**CHANGE ORDER No. 10****DATE:** 4/7/2024**P.O. #:** 006219**PROJECT NAME:** Menifee Fire Station #5**PROJECT NO:** CIP 21-04**CONTRACTOR:** Act 1 Construction**DESCRIPTION OF CHANGES AND/OR EXTRA WORK:**

Project Information	
Project #	CIP 21-04
Title	Menifee Fire Station #5
Address	29745 Goetz Rd
City, State, Zip	Menifee, CA 92587
Country	U.S

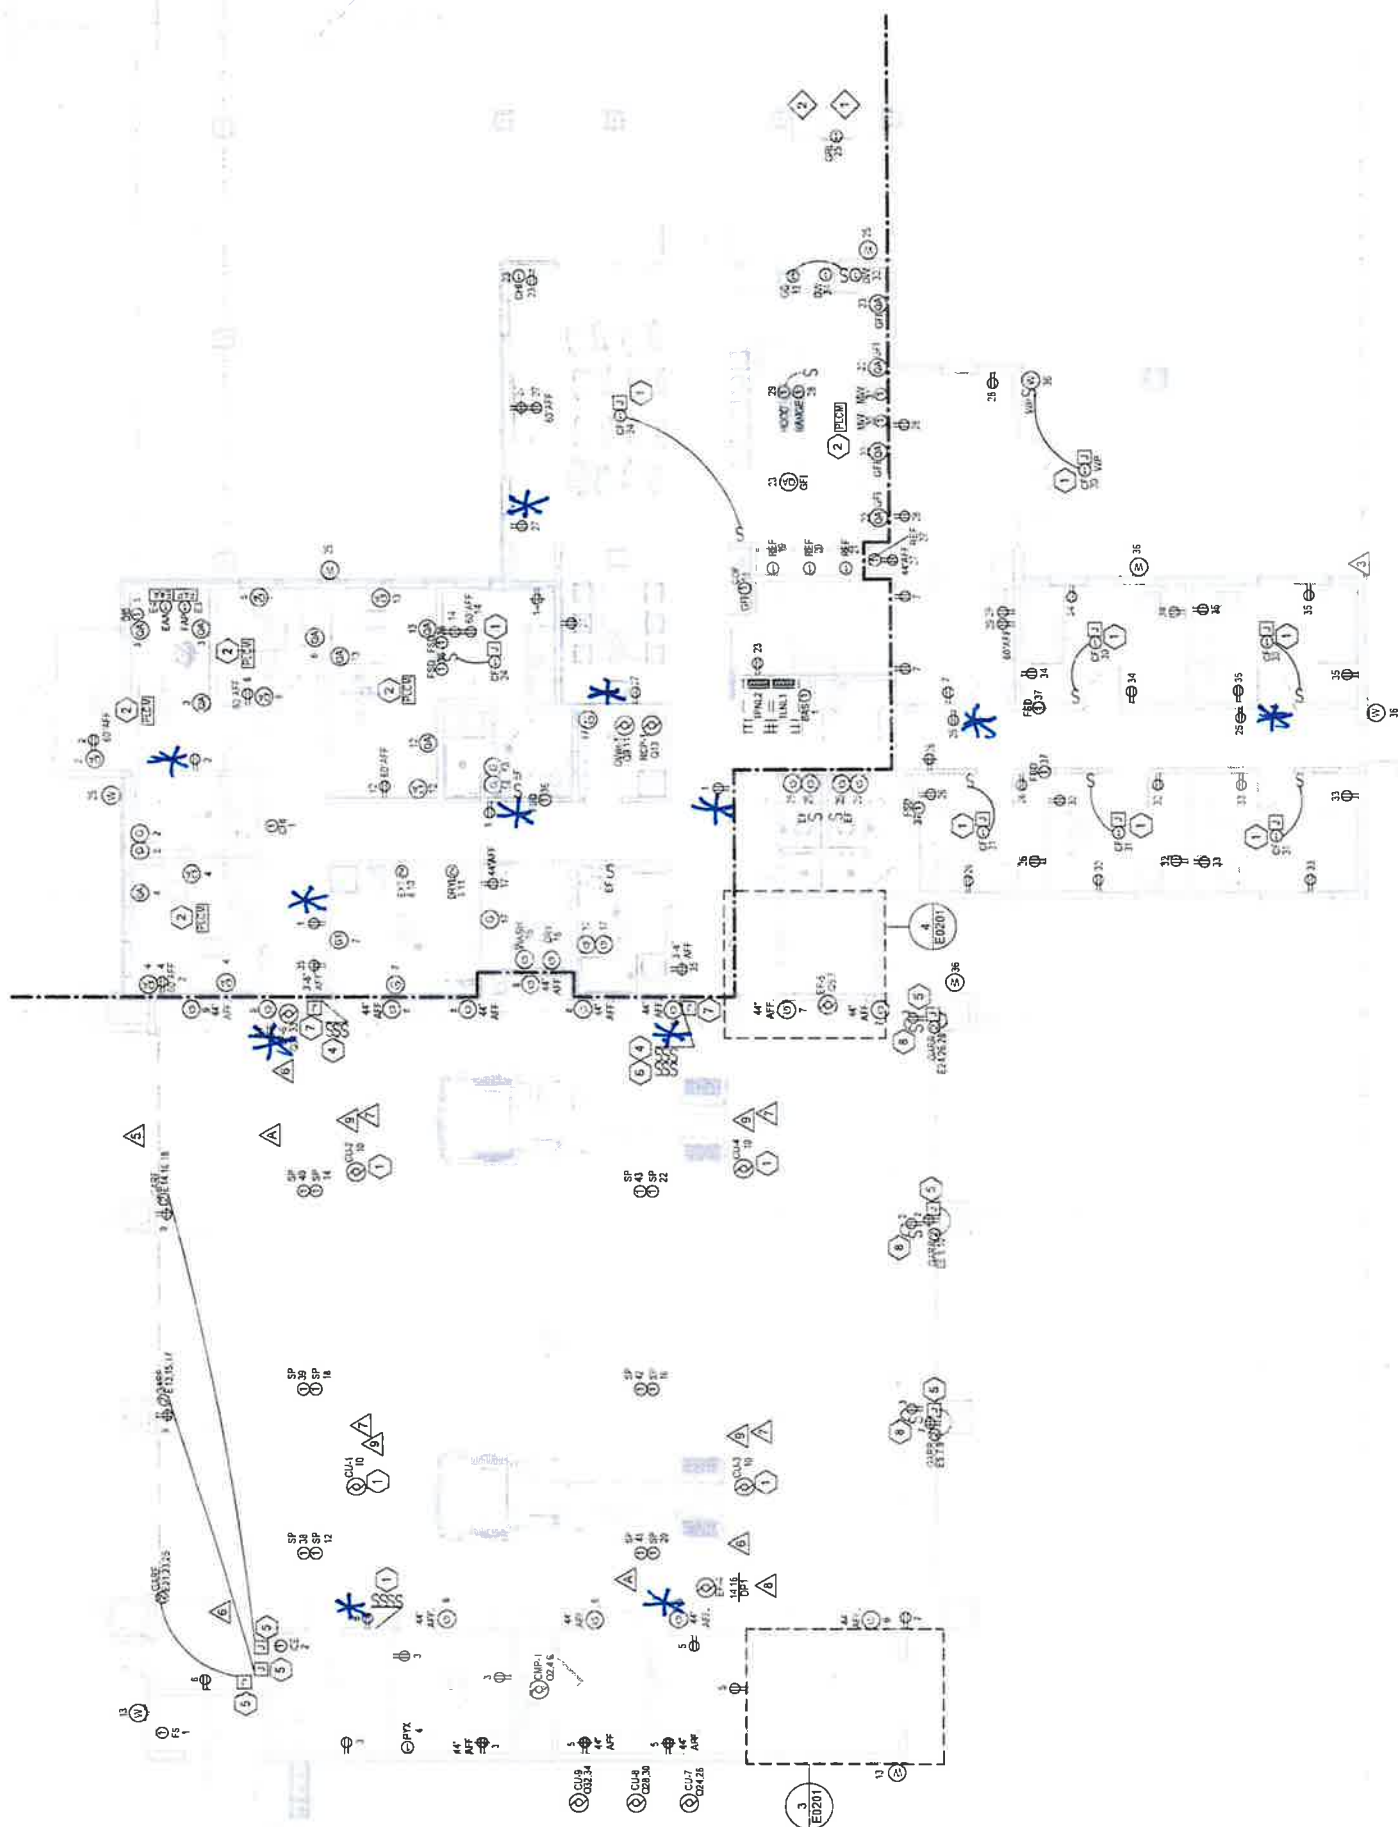
Cost to furnish and install (12) temporary emergency lights. We will mount light to wall and then run exposed cord from light down to nearest receptacle. See attached plan for locations. We will remove lights after generator is installed and operational.
